OUR REF 240407L23

29 CHARLES CRESCENT, TAUPŌ : FURTHER INFORMATION RESPONSE

Thank you for your Further Information letter on 23 July 2025. This letter responds to matters raised in your request with associated information. Also provided alongside this letter is an amended application document (Cheal ref 240407AP2), a full set of amended plans as Appendix 2 (JT Design plans), and an amended Appendix 3 (District Plan Assessment).

Image 5 : Southern Driveway (4 users)

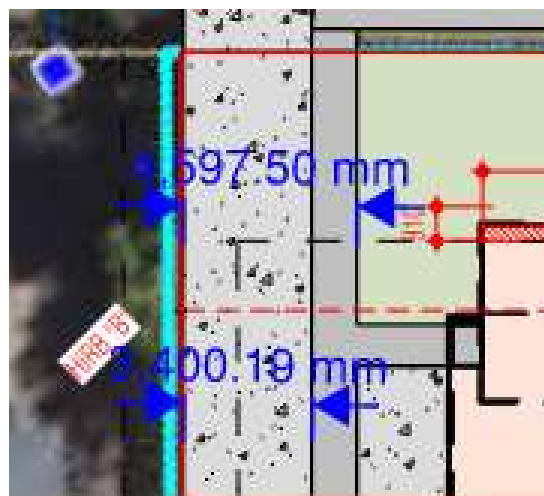
- c. Please provide a dimensioned plan to show each proposed vehicle crossing width and driveway width (legal width and formed carriageway).

For the purpose of your understanding, the scale on each page is provided already in the bottom title block of the plans. If this is not clear, please see Images 5 & 6 below, relating to the shared southern and central driveway. This information is already included in Amended District Plan Assessment.

4.6m legal - noncompliant

3.4m physical (excluding footpath)/4.6m physical (including walkway) – compliant

Image 7 : Unit 16 crossing with pram crossing

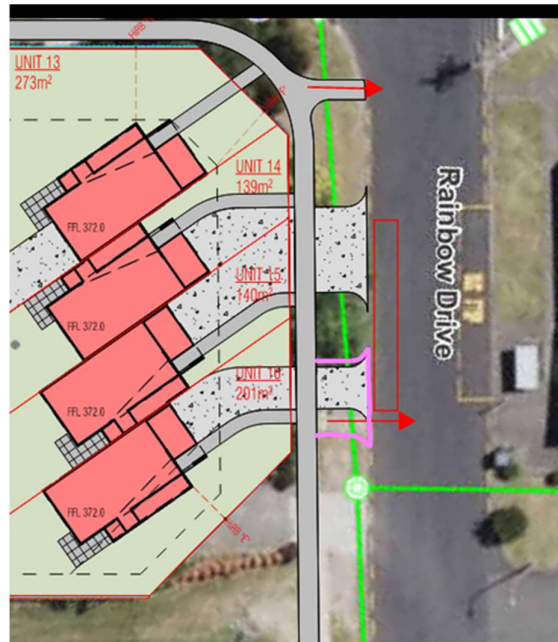
- c. **Please provide details of the proposed bus stop relocation. Are the works/costs included in the proposed development? Will the footpath crossing point/pram crossing on the south side of Rainbow Drive (outside the site) and inline with the footpath crossing point to the shops opposite, also be relocated? TDC Transportation has also advised that WRC public transport operations and Tranzit should both be involved in discussions on bus stop relocation. Please provide evidence of this consultation if it has been carried out or provide update on discussions, and any proposed conditions of consent relating to these works.**

Bus stop relocation is under discussion with TDC Transportation, and further information on that matter will be provided shortly.

It is noted that between Lake Terrace and Charles Crescent there are three crossing points over Rainbow Drive. TDC Transport has confirmed that they would like to retain all three crossings. The crossing adjoining Unit 16, can be accommodated by widening Unit 16 crossing slightly in place of a separate pram crossing. TDC Transport has suggested this as a suitable outcome as per Image 7. A condition of consent on this matter is therefore anticipated.
